CITY OF HOBART

CITY PLANNING COMMITTEE MEETING

MONDAY, 28 OCTOBER 2019

11. 52, 48-50, 46 New Town Road, 7A Clare Street and Adjacent Road Reserve, New Town - Demolition, New Building for Hospital Services, Business and Professional Services, and General Retail and Hire, Signage and Associated Infrastructure Works
- A. Deputation Supporting Documentation of David Reilly, Chris Clinton, Glenn Woodfall and Allison Turnock (Representors).....2
- B. Deputation Supporting Documentation of Irene Duckett, Stephen Penglase and Geoff Schaedel on behalf of the Proponent.....69

West elevation of hospital in red with IMAS overlaid in blue

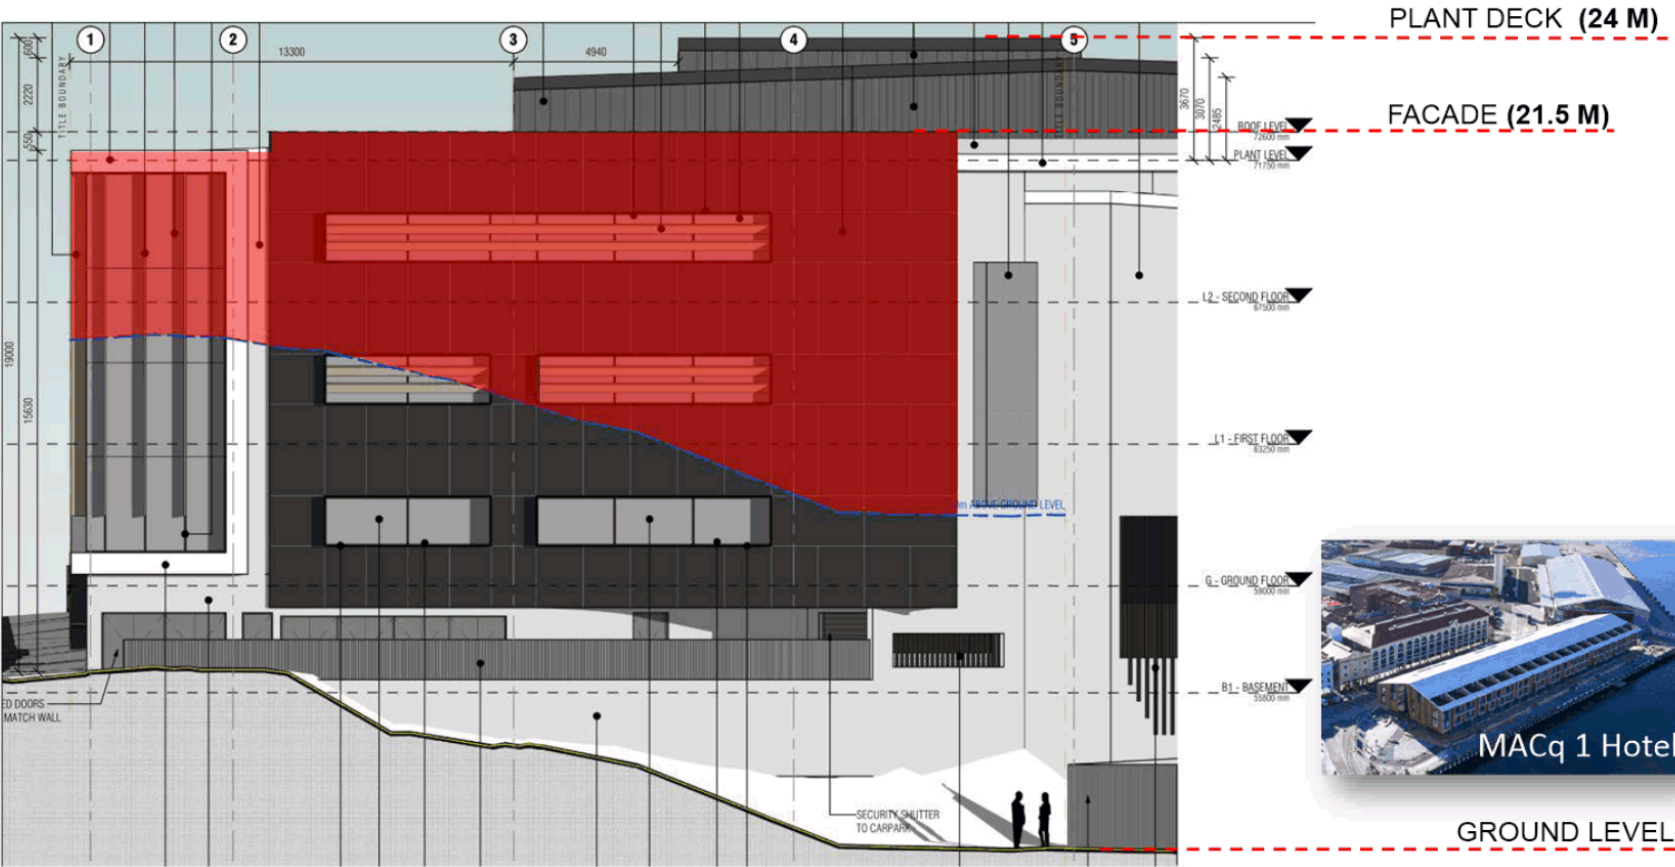
HEIGHT & SCALE

Incompatible height
Severe harm to amenity
Deficient information

Transition to Seymour St & Clare St properties
(absent from Planning Report)

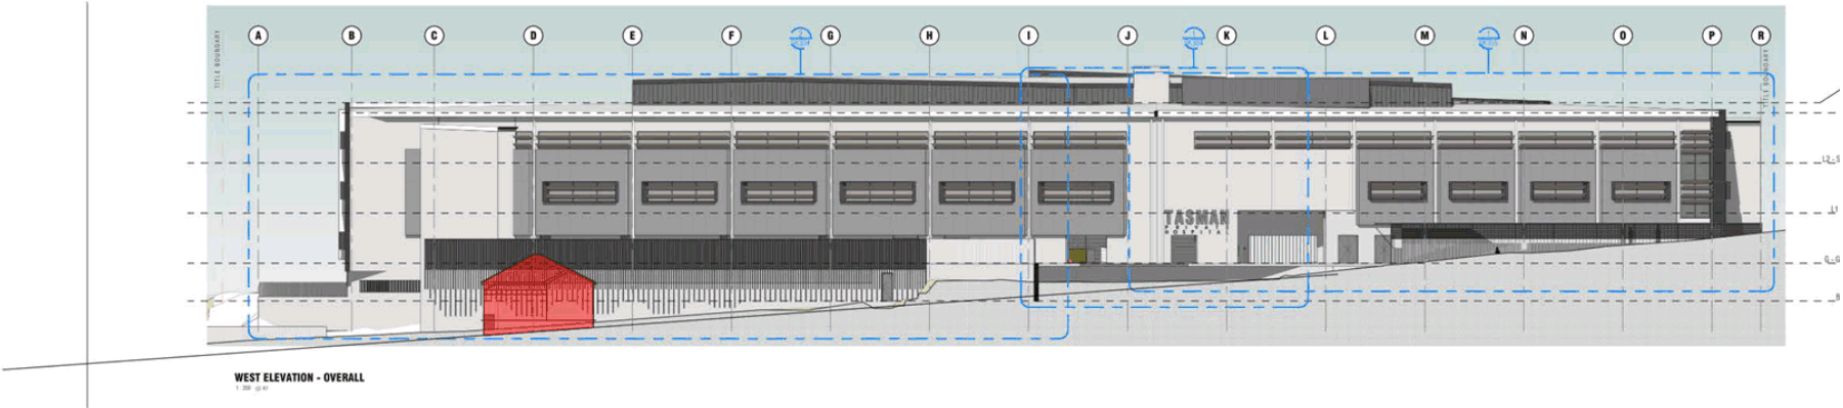
Incompatible scale
Failure to transition
Negative streetscape contribution
Selective information

NORTH-WEST SIGHTLINE SECTION 1
1 : 200

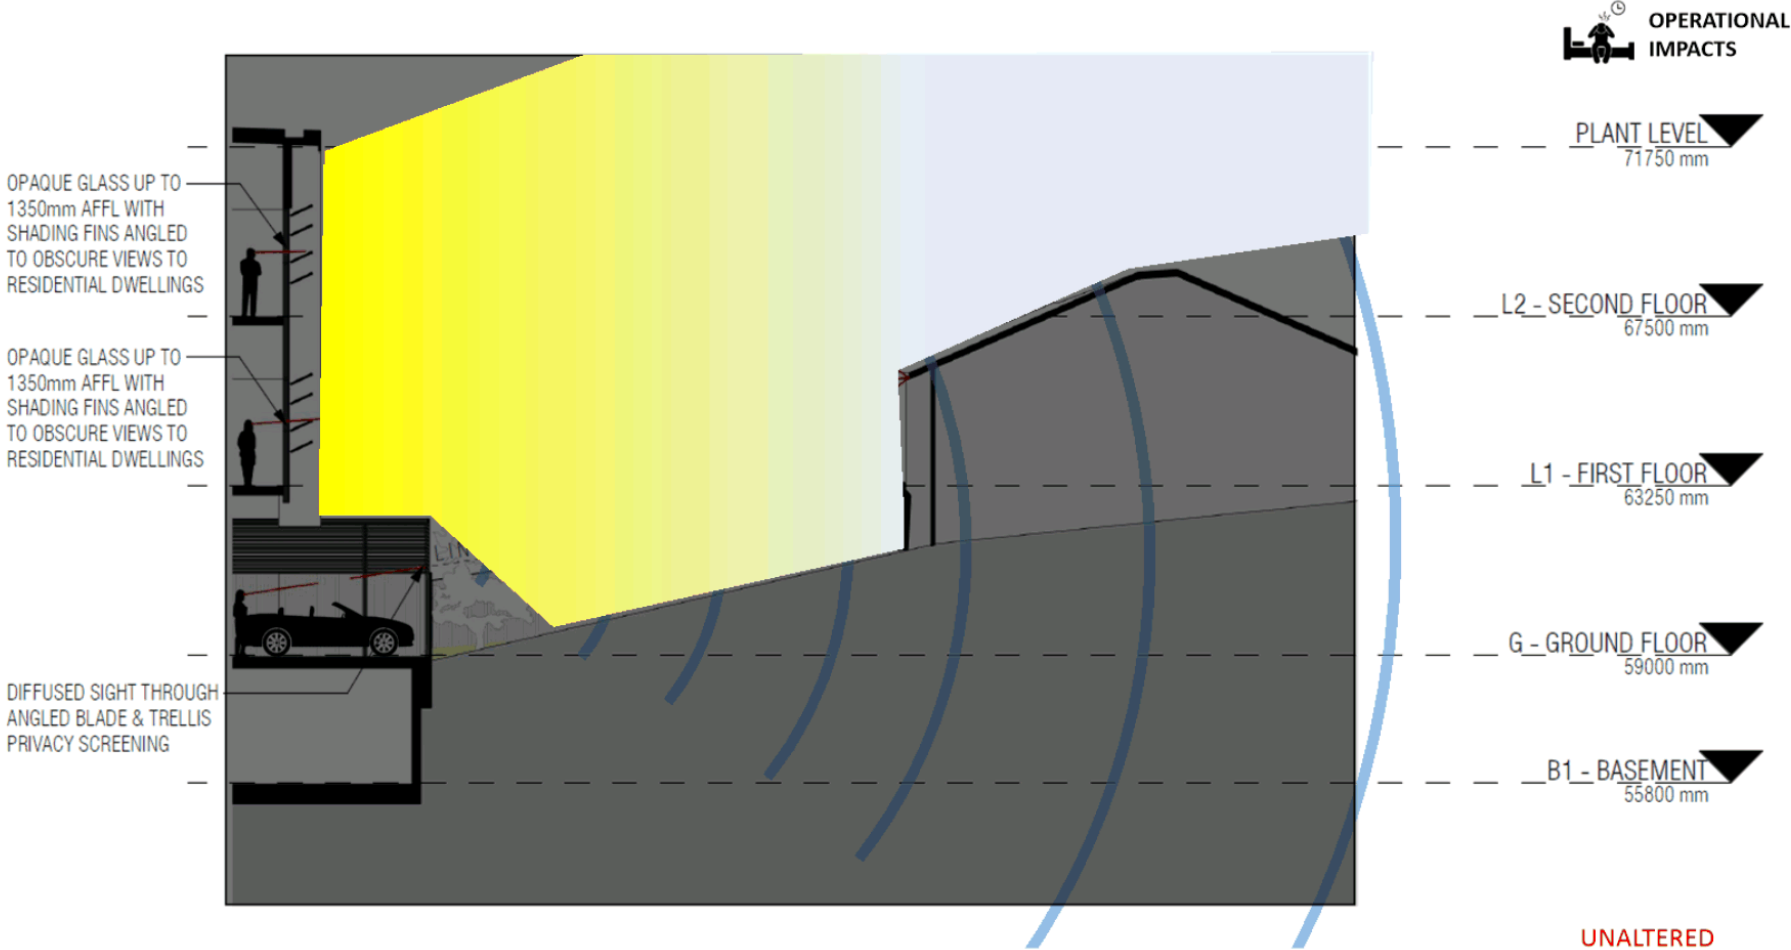
- (a) safe and efficient access is provided to all road network users, including, but not limited to: drivers, passengers, pedestrians, and cyclists, by minimising:
 - (i) the number of vehicle access points; and
 - (ii) loss of on-street car parking spaces;
- (b) vehicle access points do not **unreasonably detract from the amenity of adjoining land uses**;
- (c) vehicle access points do not have a dominating impact on local streetscape and character.

The number of vehicle access points provided for each road frontage must be no more than 1 or the existing number of vehicle access points, whichever is the greater.

Clare St
12 Sept 2019
Circa 2:45pm

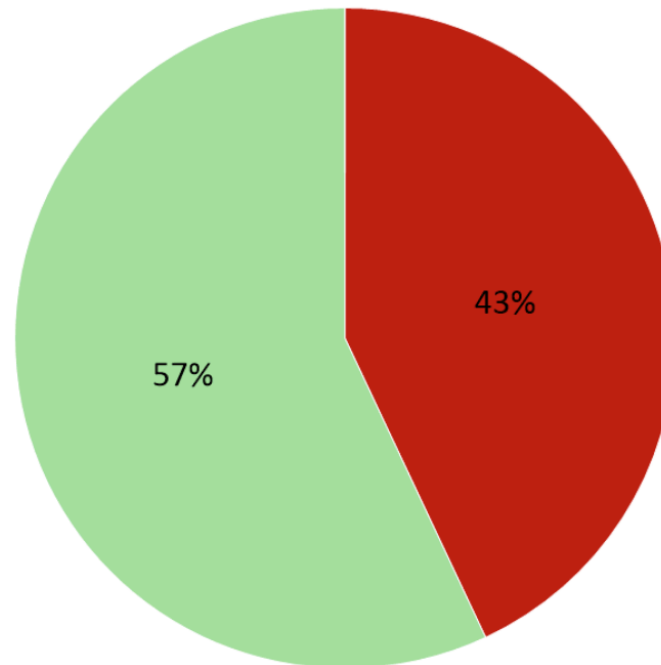
Parking space deficit

Overspill likely

Compounding existing parking problems
